## TEMPORARY SUBSTITUTION AUTHORITY

TSA NO. 1690

DMC 12 MIDDLE EAST SPEC - ALREADY BUILT

REPLACEMENT OF MOTOROLA ALTERNATOR 110101 WITH THE DUCCELLIER UNIT WHICH WAS SUPPLIED ON EARLY ENGINE ASSEMBLIES.

# METHOD OF FIXING DUCELLIER ALTERNATOR FOR MIDDLE EAST CARS

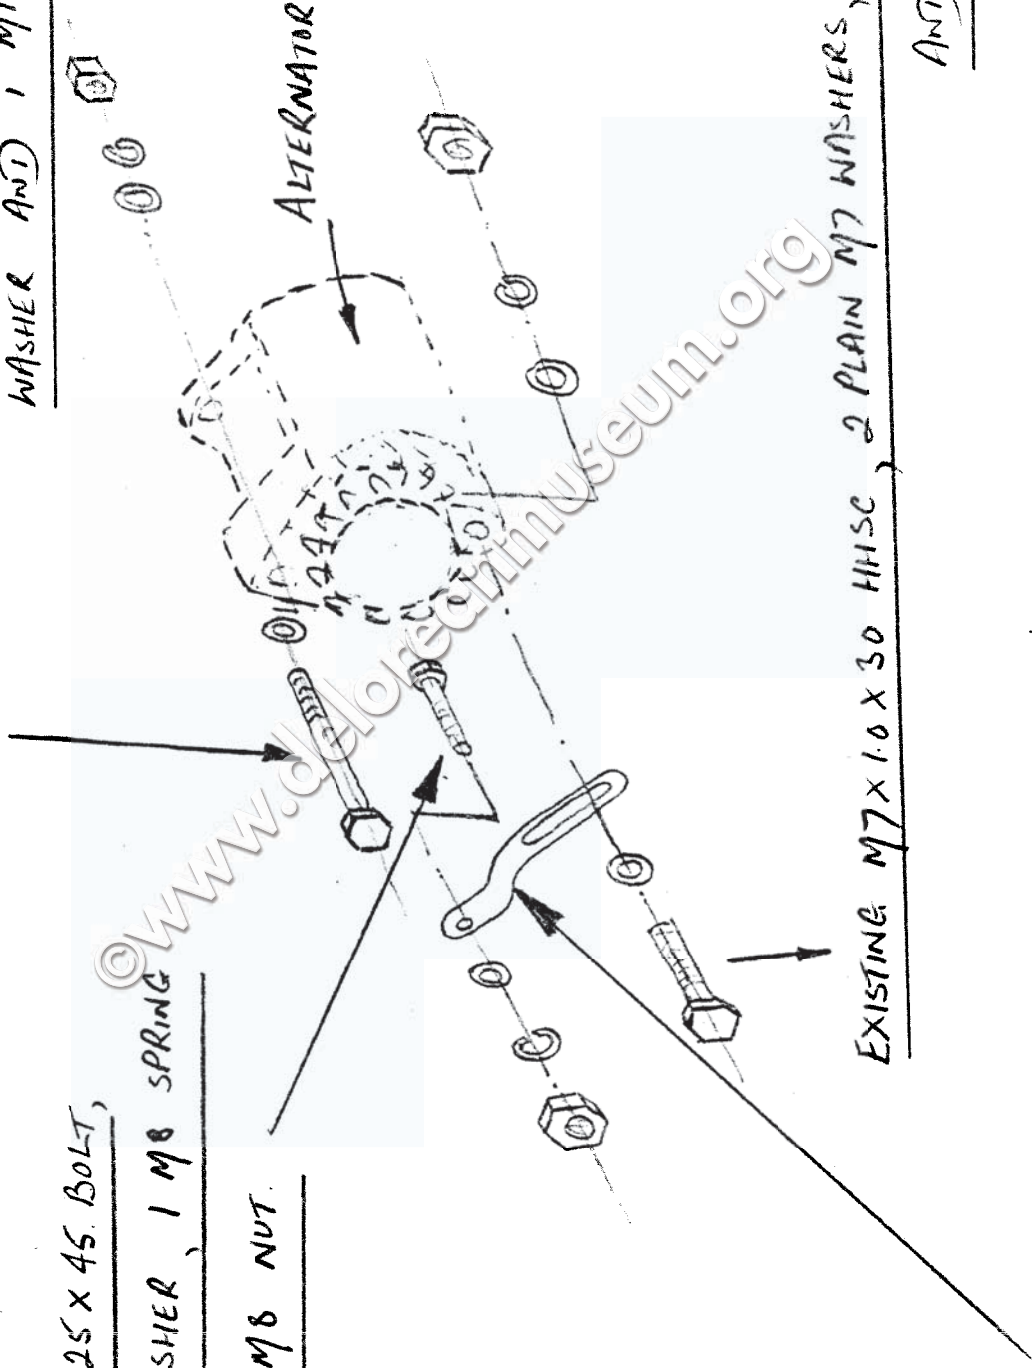
MOUNT NEW SLOTTED BRACKET AS SHOWN (OPPOSITE TO THE WAY IT IS FITTED WITH A MOTOROLA

ALTERNATOR)

EXISTING M10 X 15 X 120 BOLT, 2 PLAIN M10 WASHERS, 1 M10 SPRING

EXISTING M8 X 1.25 X 45 BOLT,

EXISTING M7 X 1.0 X 30 HHSC, 2 PLAIN M7 WASHERS, 1 M7 SPRING WASHER

BELT TENSION REGULATING BRACKET  
(AS PER MOTOROLA ALTERNATORS.)

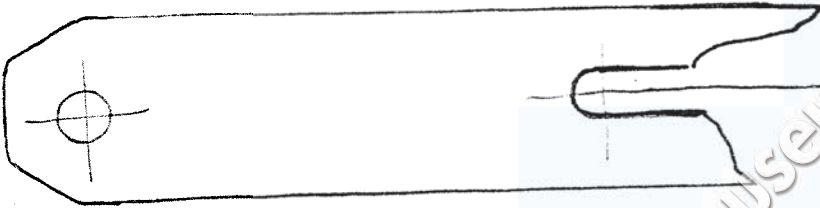
BELT TENSION REGULATING BRACKET  
(AS PER DUCELLIER ALTERNATORS)
